ADDENDUM

Forestside Estates
Attmar & Palleschi Drive
Brampton, Ontario
Attn: **Vince Staffieri**

AM 08

PROJECT	**: Forestside**
PROJECT #	**: 1331.15**
DATE	**: Jan 18, 2021**

FORTH FLOOR OVERALL PLAN

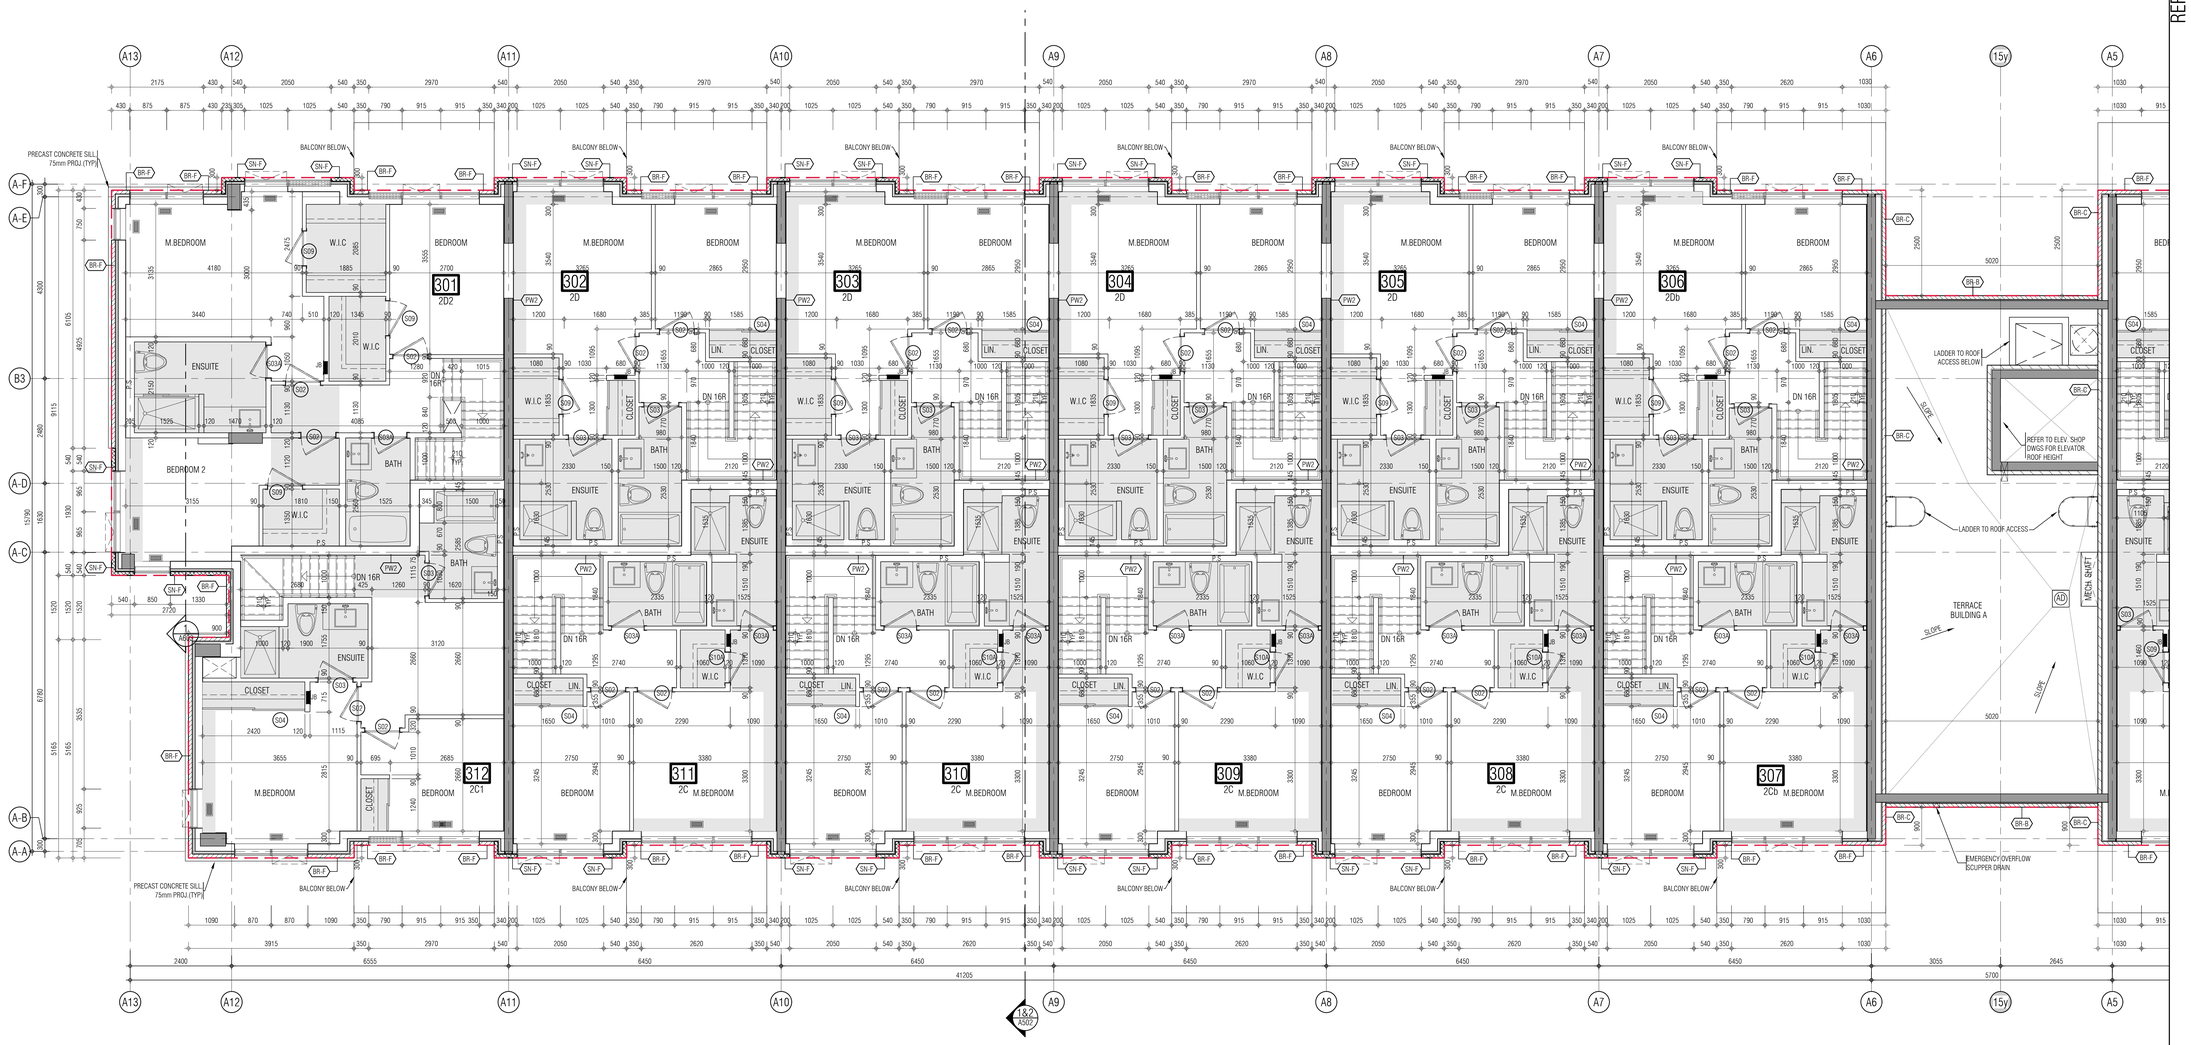
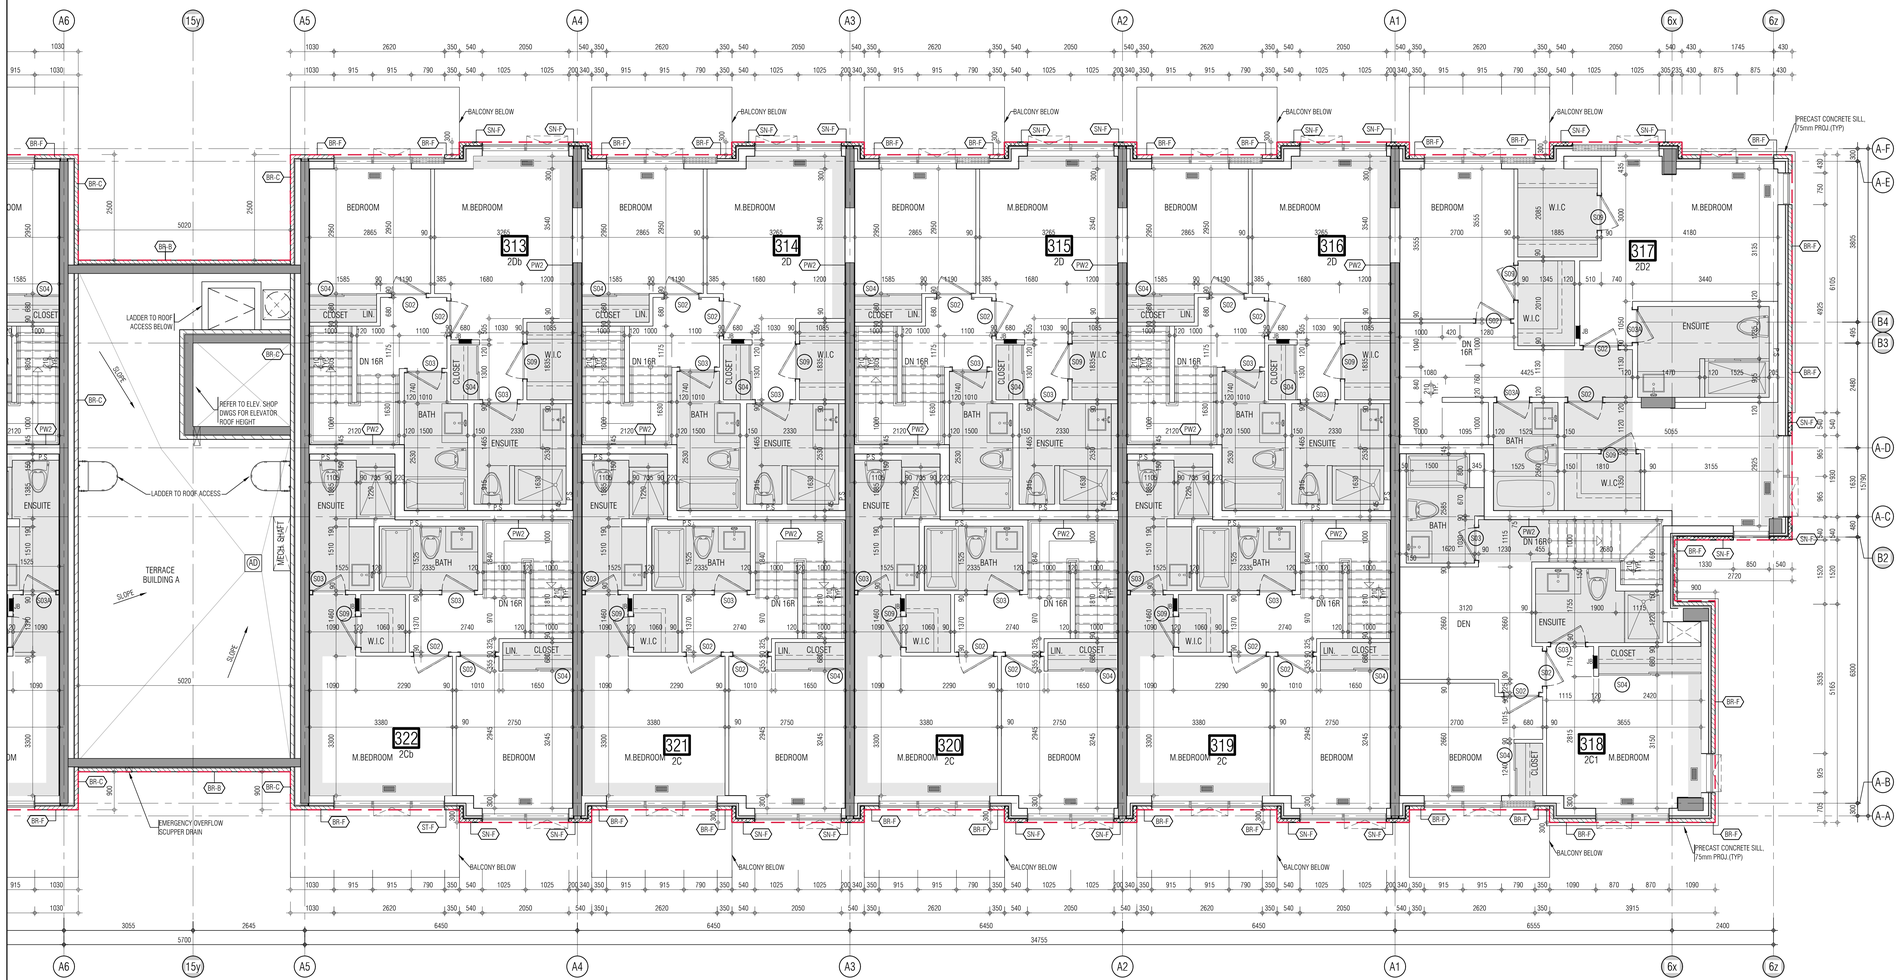
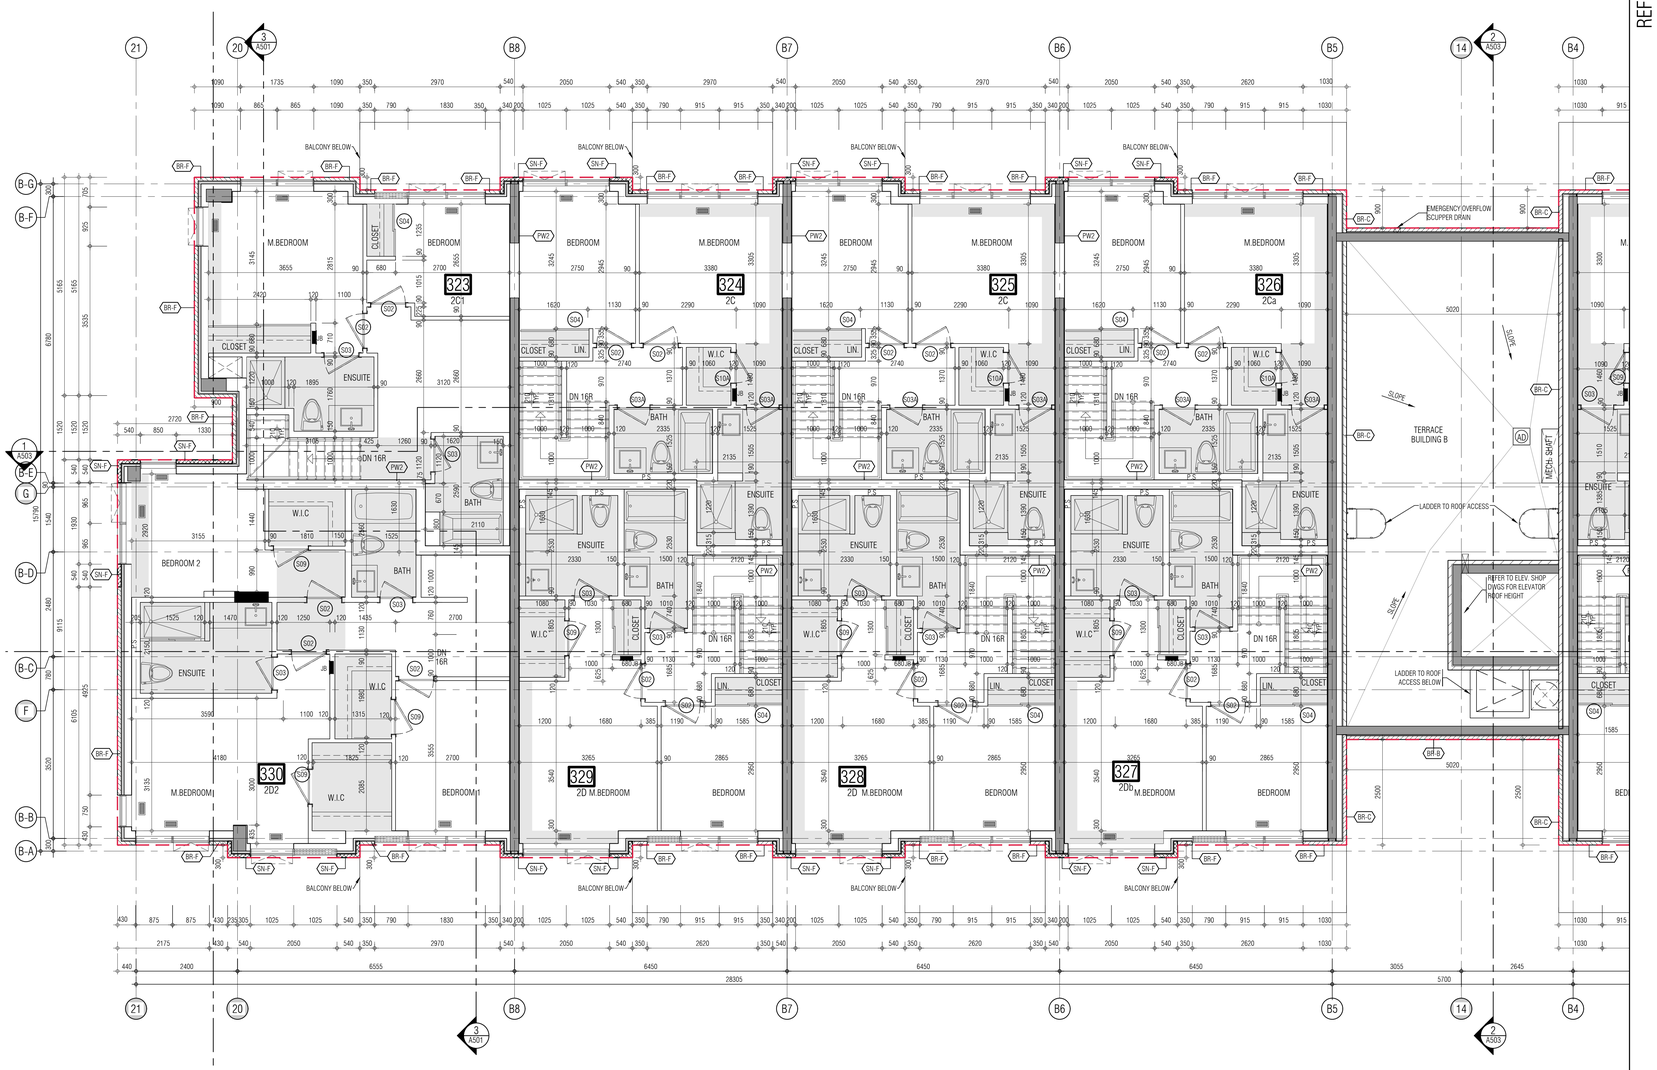
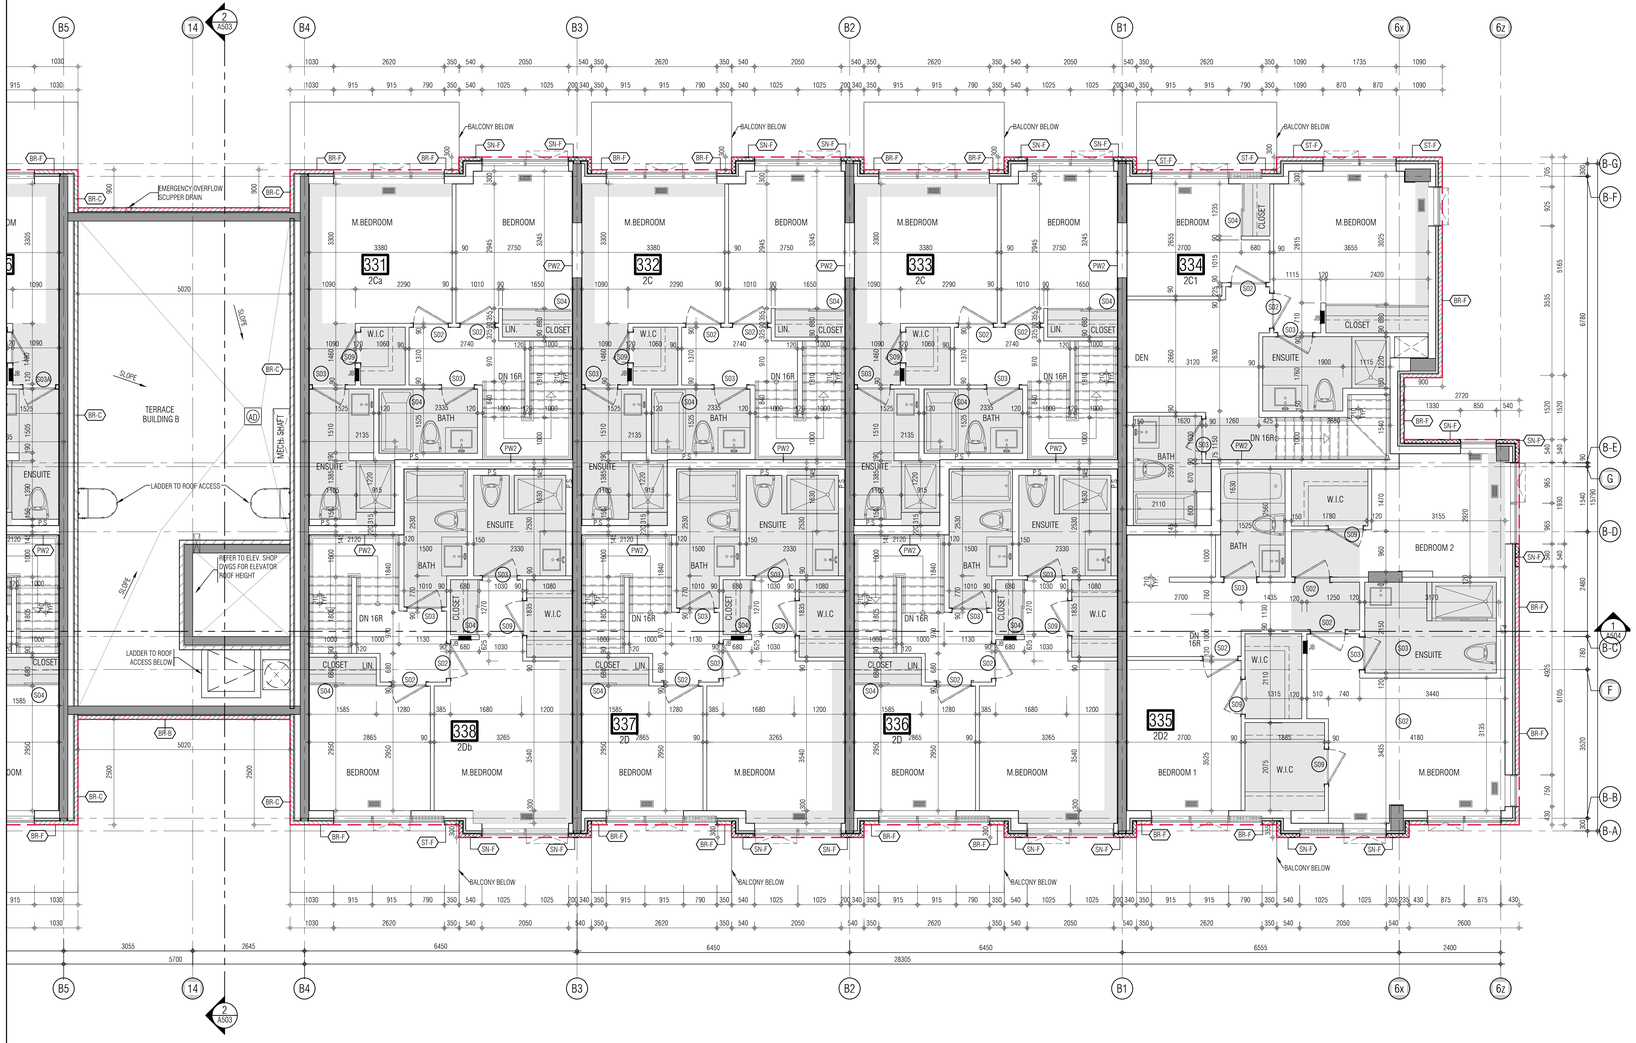
A301-A304	1st – 4th Floor Plans	• Move Blocks A and B north 286mm to comply with 0.3m easement and 3.0m minimum set back to property line as per clients request. • Move Block D up 390mm along angle north to comply with 0.3m easement and 3.0m minimum set back to property line as per clients request.
A701a-A701b	Stair Sections	• Revised dimensions on stair plans to match blocks that were moved.
